March 19, 2010

Thank you for the opportunity to comment on the Draft Tank Closure and Waste Management Environmental Impact Statement (Draft TC & WM EIS) for the Hanford Site, Richland, Washington (DOE/EIS-0391-D) prepared by the U.S. Department of Energy (USDOE). This letter, including the attachments, summarizes and transmits the Yakama Nation's comments and concerns regarding the alternatives presented in the Draft TC & WM EIS.

Yakama Nation ERWM Program General Comments on the Draft Tank Closure and Waste Management Environmental Impact Statement for the Hanford Site, Richland, Washington (USDOE/EIS-0391).

Attachment 2
Hanford Tank Closure and Waste Management EIS
Yakama ERWM Program Targeted Comment Compilation
March 12, 2010

Figure N-155. Fluxes of Iodine-129 at the Water Table for Two Waste Forms for the 70 Percent Partition to Immobilized Low-Activity Waste Glass Case

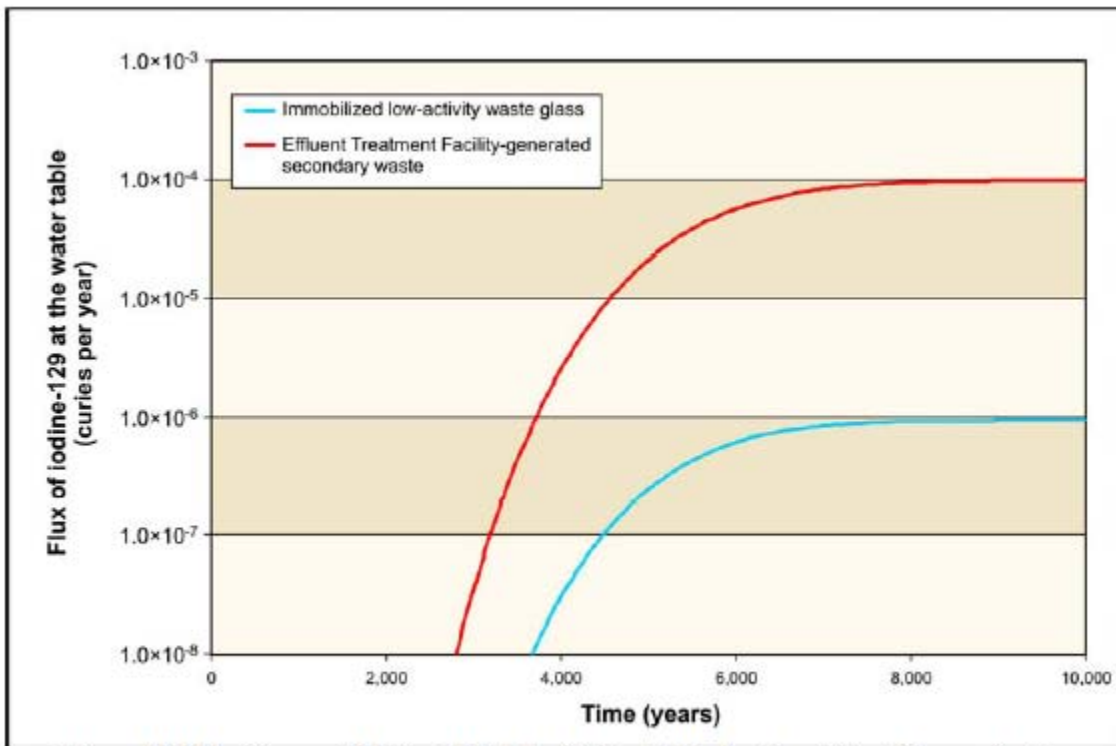
The current plan to dispose of iodine-129 in a secondary waste stream in the Effluent Treatment Facility (ETF) is clearly unsatisfactory. The TC&WM EIS analysis shows that the annual flux of iodine-129 at the water table is orders of magnitude greater in case of ETF disposal compared to incorporation in ILAW glass that is disposed of on site. The figure below, reproduced from Appendix N of the EIS, shows that iodine-129 contamination of the groundwater would exceed that from ILAW by two orders of magnitude even when the majority of the iodine-129 (70 percent) is incorporated in the ILAW.
